PROJECT: Summitlin West V22-Flight Edge Way
(From Kettle Bend to Desert Foothills)

CITY OF LAS VEGAS		DATE:
INTER-OFFICE MEMORANDUM		April 21, 2020
TO: Land Development Services Department of Building & Safety		FROM: Albert Sung, P.E. Flood Control Project Engineer Department of Public Works
SUBJECT:	Drainage Study for:	COPIES TO:
	Summerlin West V22 – Flight Edge Way (from Kettle Bend to Desert Foothills)	VTN Nevada
Cross Streets:	Desert Foothills Blvd. & Flight Edge Way	Howard Hughes Company, LLC
File Number:	F:\Depot\DSMemos\DS5252B.doc	Bart Anderson, P.E., DevCo
Parcel Number:	137-23-201-001	CCRFC
Zoning Action:	N/A	
FEMA Flood Zone	YES	NO X
Proposed Storm Drain	YES	NO X

ADDENDUM #1
TO THE TECHNICAL DRAINAGE STUDY
FOR
V22 FLIGHT EDGE WAY –
KETTLE BEND TO DESERT FOOTHILLS
DS-5252
CITY OF LAS VEGAS, NEVADA
W.O. # 7861

This Addendum #1 to the Technical Drainage Study for V22 Flight Edge Way – Kettle Bend to Desert Foothills (DS-5252) is being submitted to the City of Las Vegas Department of Public Works to address review comments dated March 17, 2020.

DRAWING NO: UT3

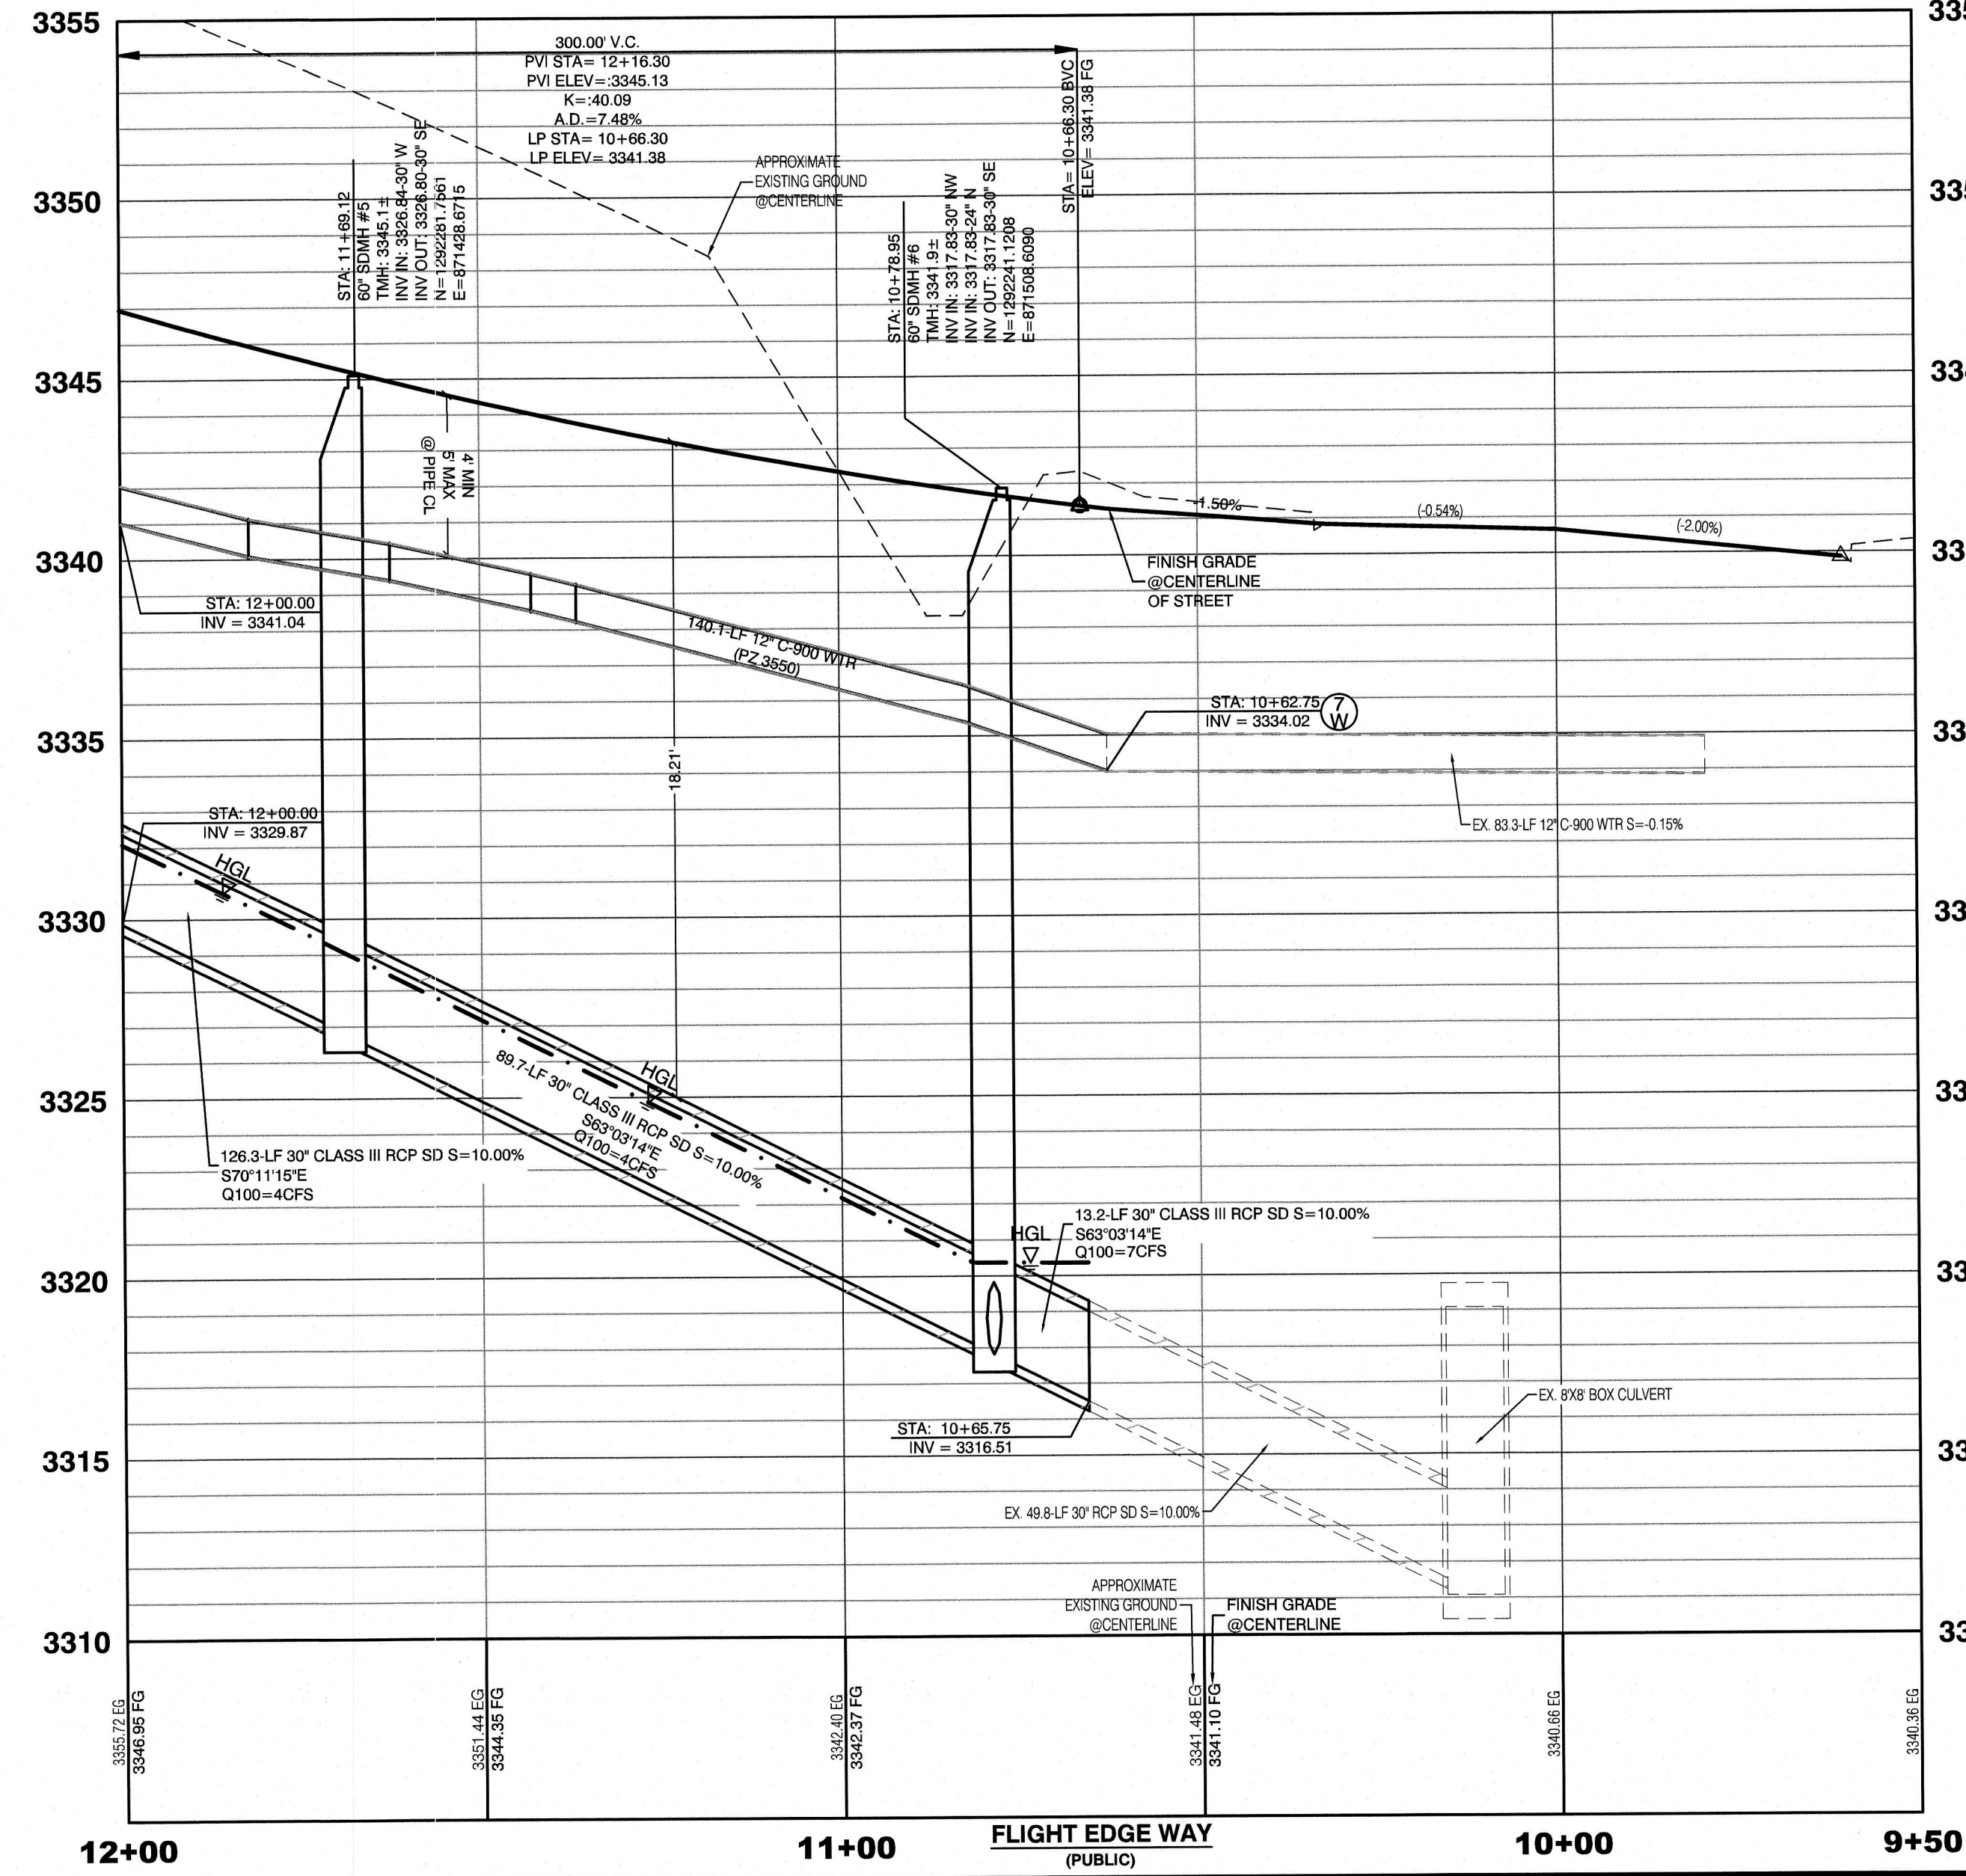
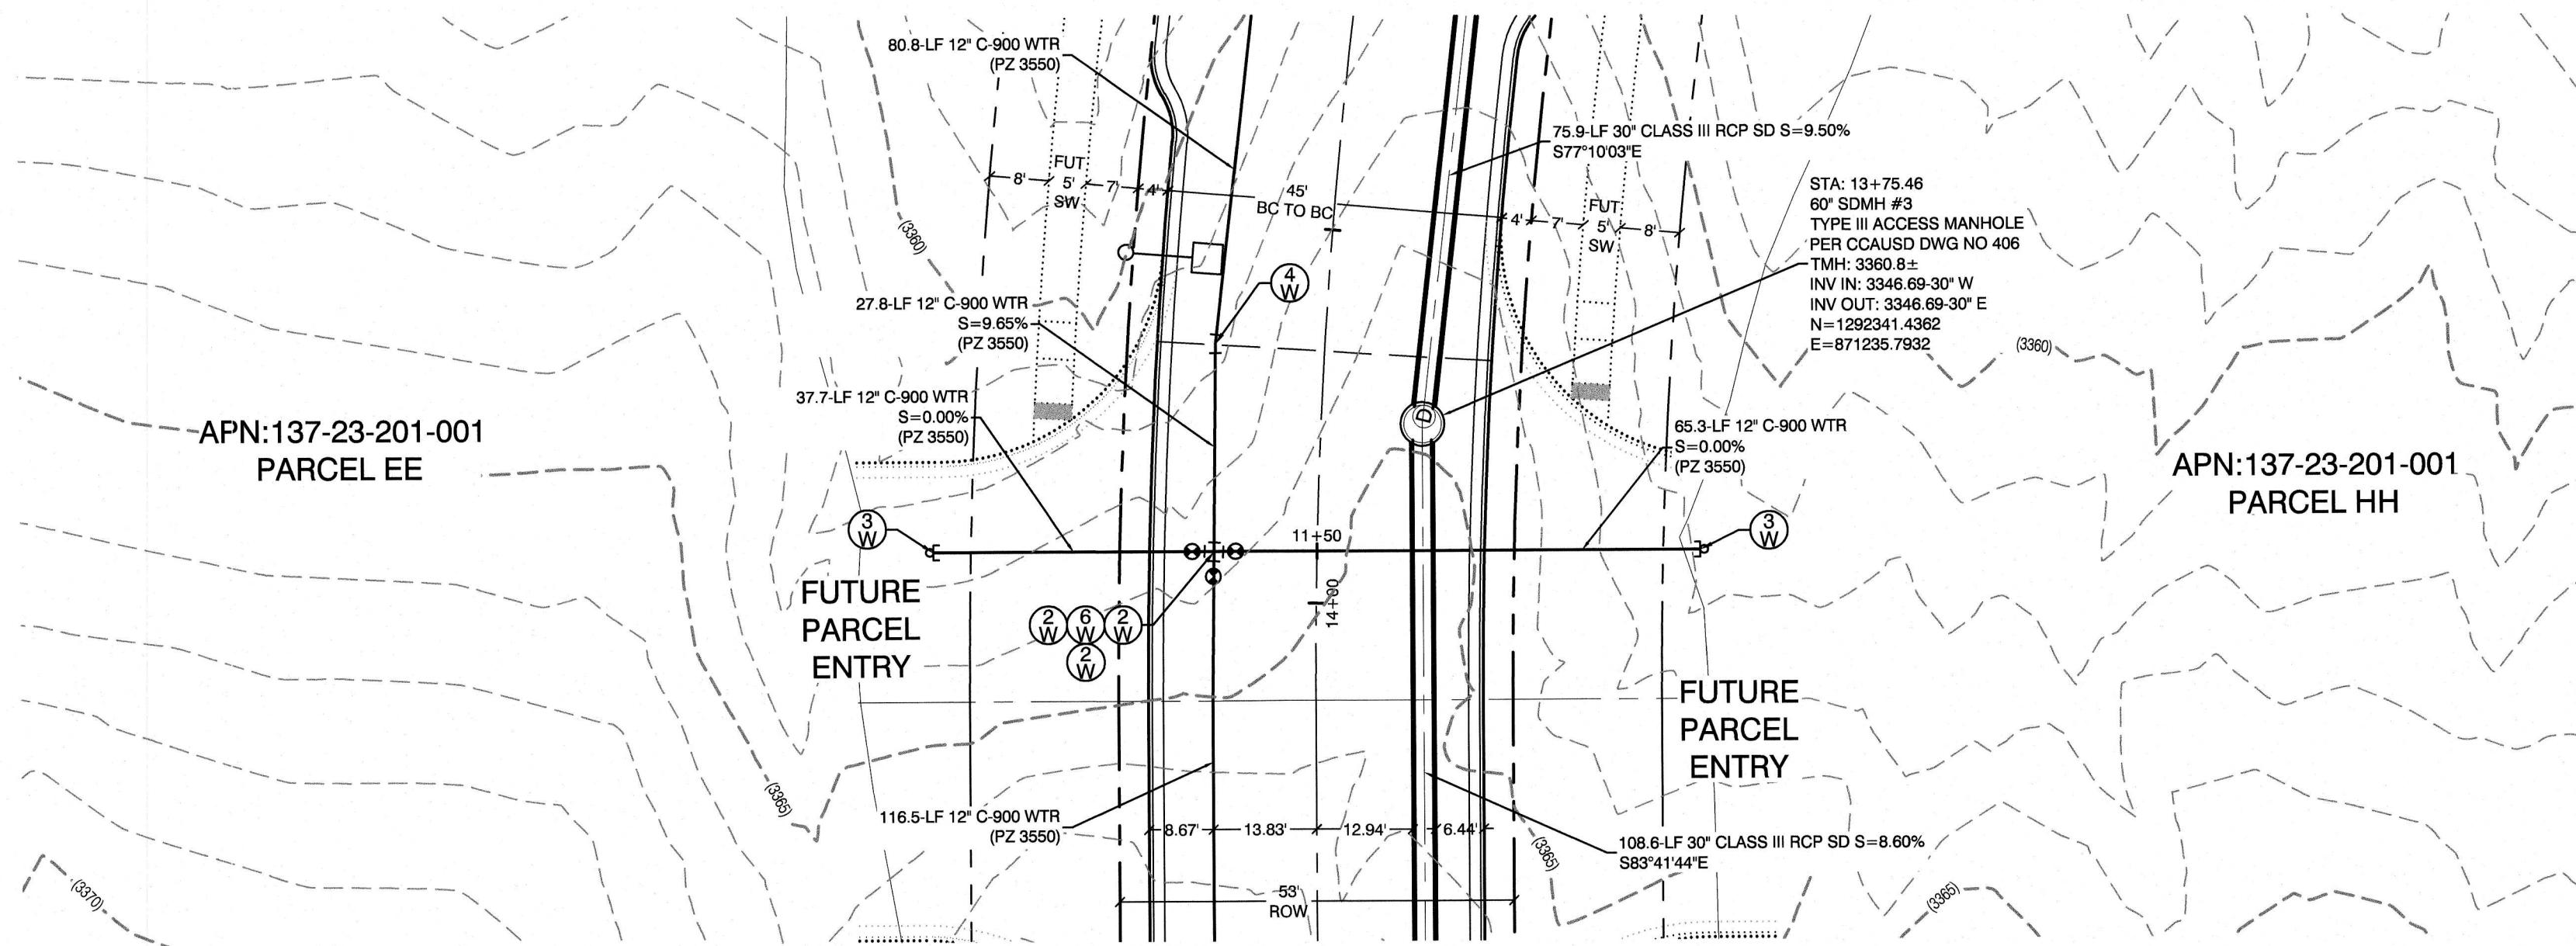
Sheet UT3 and Sheet UT7: At the connection point between the existing 30" RCP and the new one in Flight Edge Way, provide a connection detail such as collar in the next submittal.

RESPONSE: The existing RCP will be cut back to provide a clean joint as required to connect the new RCP. Note that the RCPs will have the same slope and no deflection between the existing and proposed pipes will occur. Non concrete collar is necessary.
